UNITED STATES PATENT AND TRADEMARK OFFICE

Office Action Summary	Application No. 10/525,304	Applicant(s) GAO, XIN WEI	
	Examiner Noah C. Hawk	Art Unit 3636

DETAILED ACTION

Chai '476, Figure 6

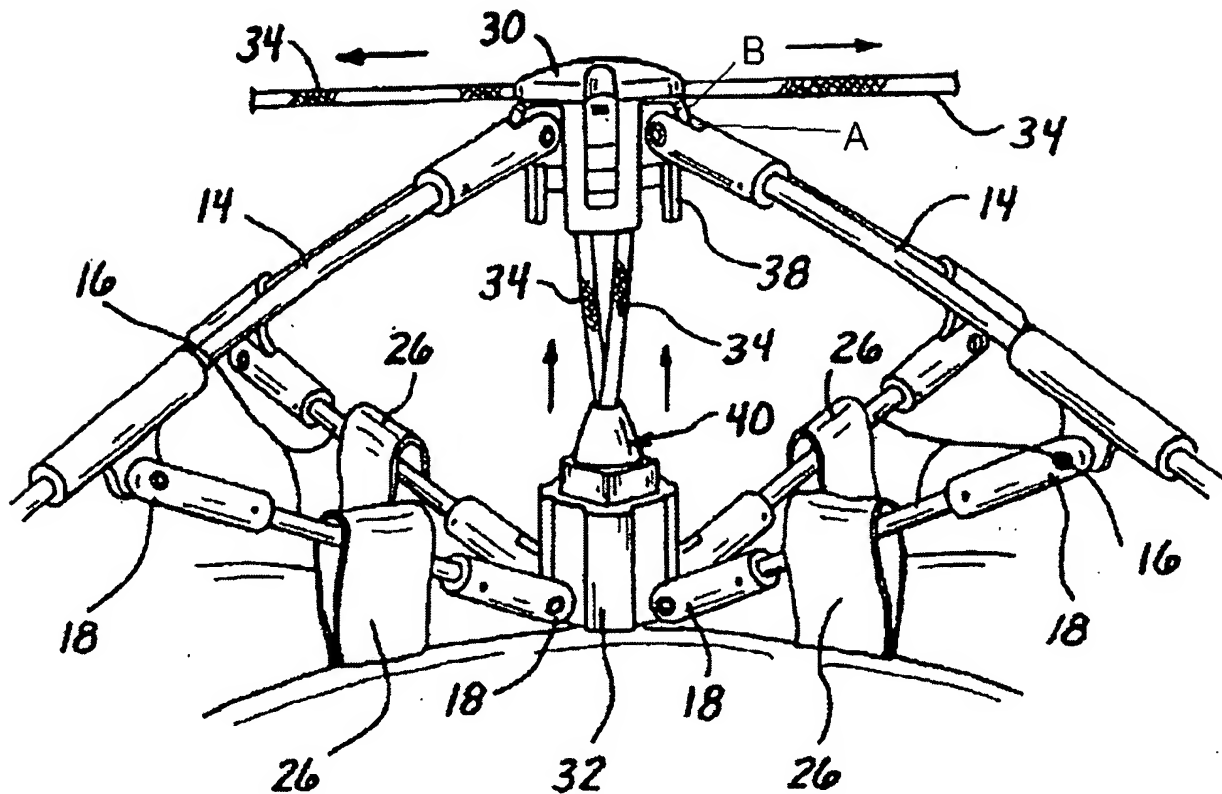
c. Regarding Claims 3 and 8, Chai, as modified, teaches that the upper central head includes a base (38) and a cap (30), the base including racks (A) which are closely coupled with grooves (B) at inner surfaces of the connectors and a protrusion (40) is formed on the lower central head for inserting into an opening in the base of the upper central head (Best seen in Chai, Figures 6 and 7).

Chai '476, Figure 4

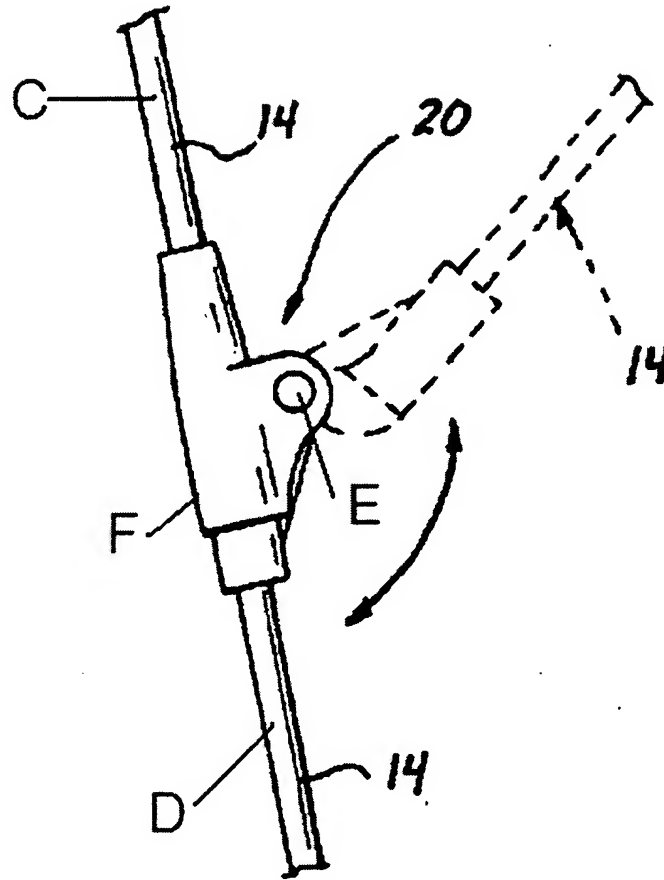
- d. Regarding Claim 5, Chai, as modified, further teaches that the umbrella-type frame and the spreaders are composed of short bars (14 and 16, Best seen in Figures 3, 6, and 7) connected to each other.
- e. Regarding Claim 9, Chai, as modified, further teaches that a connector (E) is positioned at a junction of the rib (C) and a short ground supporting bar (D) an upper short bar of the rib is hinged by the connector and a board (F, insofar as the applicant discloses the "board") is positioned on an inner side of the connector to prevent the rib from bending inward.
